REV A UNTESTED

Sheet: /
File: nixitest1.kicad_sch

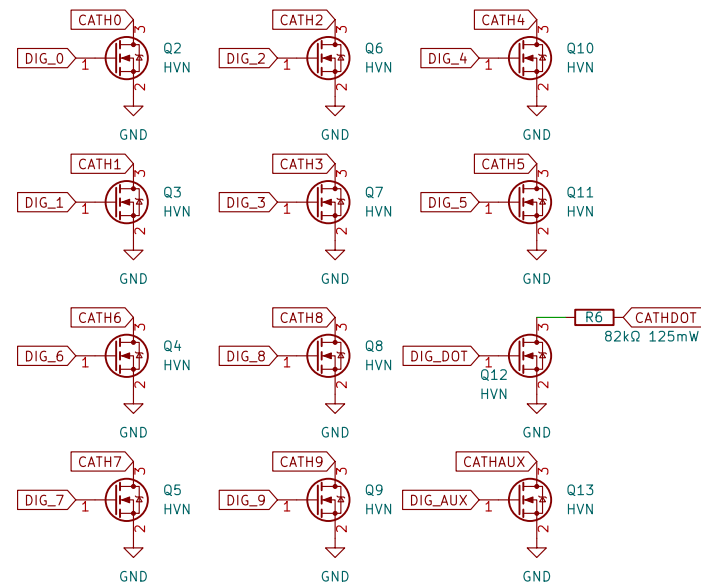
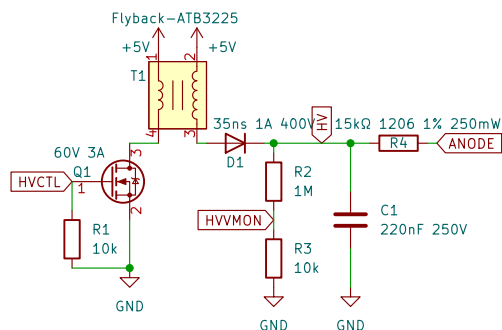
Changes in RevA

- * Probably remove HVIMON >> DEFINITELY
- * Include pull-down on HVCTL >> DEFINITELY.
- * Monitor ripple on HVP (NOT AN ISSUE)
- * Switch resistors to 15k
- * Transformer should have both rails tied to 5V
- * Aux resistor independent of anode resistor.
- * Aux Neons in series.
- * Shrunk bulk capacitor to 1206
- * Feedback resistor to 1206

TODO:

Mod HW per Ivan.

- * Shrink binding post holes.
- * Mark off which pin on header is PGM
- * Reduce power to comma
- * Flip orientation of tube?

Note: The 68k resistors are 0805 because it is infeasible for them to have > 70V across them.
